**BEFORE THE INDEPENDENT HEARING PANEL APPOINTED BY THE
QUEENSTOWN LAKES DISTRICT COUNCIL**

UNDER the Resource Management Act 1991 (RMA)
IN THE MATTER of the Te Pūtahi Ladies Mile Plan Variation in accordance
with section 80B and 80C, and Part 5 of Schedule 1 of the
Resource Management Act 1991.

**STATEMENT OF REBUTTAL EVIDENCE OF BRIDGET MARY GILBERT
24 November 2023**

Figure 1: UGB location supported by Messrs Milne and Compton Moen. Blue line corresponds to 423m contour. Light brown line corresponds to PDP Landscape Classification Line (i.e. ONF) boundary. (Source: T Milne EiC Appendix C, page 7.)

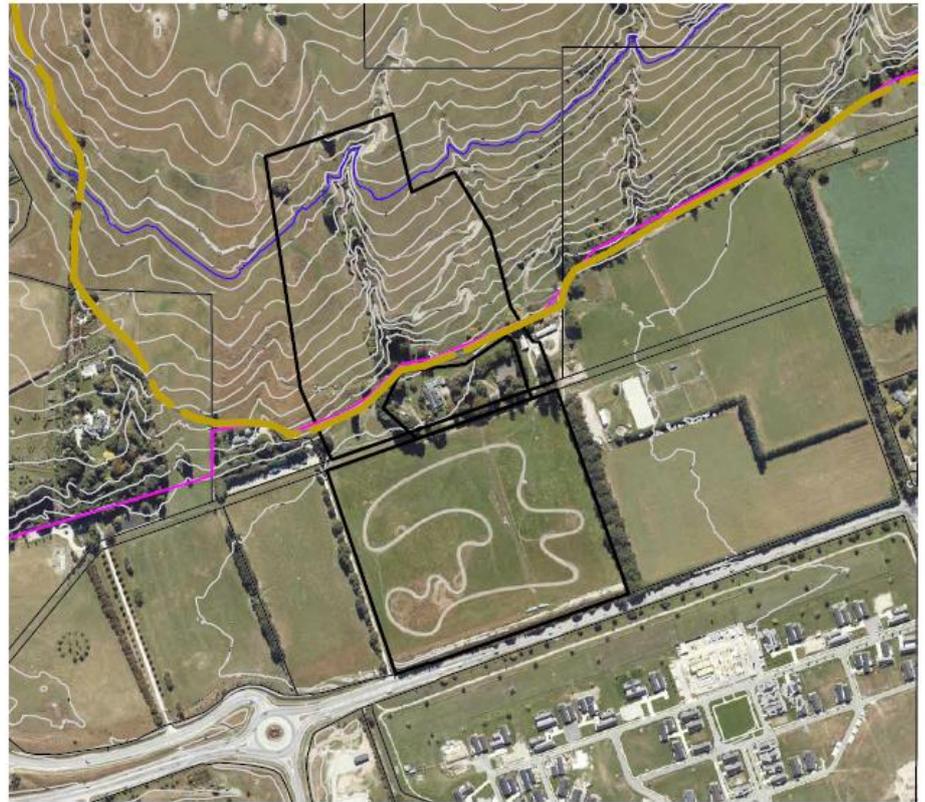
- 13 As outlined above, Messrs Milne¹ and Compton-Moen² support the delineation of the UGB at the 423m contour of Slope Hill ONF and consider that this will not compromise the 'key landscape values'³ of the Slope Hill ONF as defined in the notified version of the Slope Hill ONF Schedule.⁴ The UGB location that they support is depicted by the blue line in **Figure 1** below.
- 14 I note that both of the Glenpanel landscape expert comments in this regard stem from their understanding that water tanks are defined as 'urban development' under the Council's Proposed District Plan

- 17 Relying on Mr Brown’s planning evaluation in his rebuttal evidence, I do not consider that it is necessary to realign the UGB to incorporate the (potential) location of the water tanks.

- 18 I have also re-read *Bridesdale Farm Developments Limited*, in which the Court stated that UGBs are a tool for managing growth within distinct and defensible areas.⁸ Therefore, I remain of the opinion expressed in the Slope Hill ONF JWS that moving the UGB to overlap the ONF does not align with the intentions of PDP Objective 4.2.1.
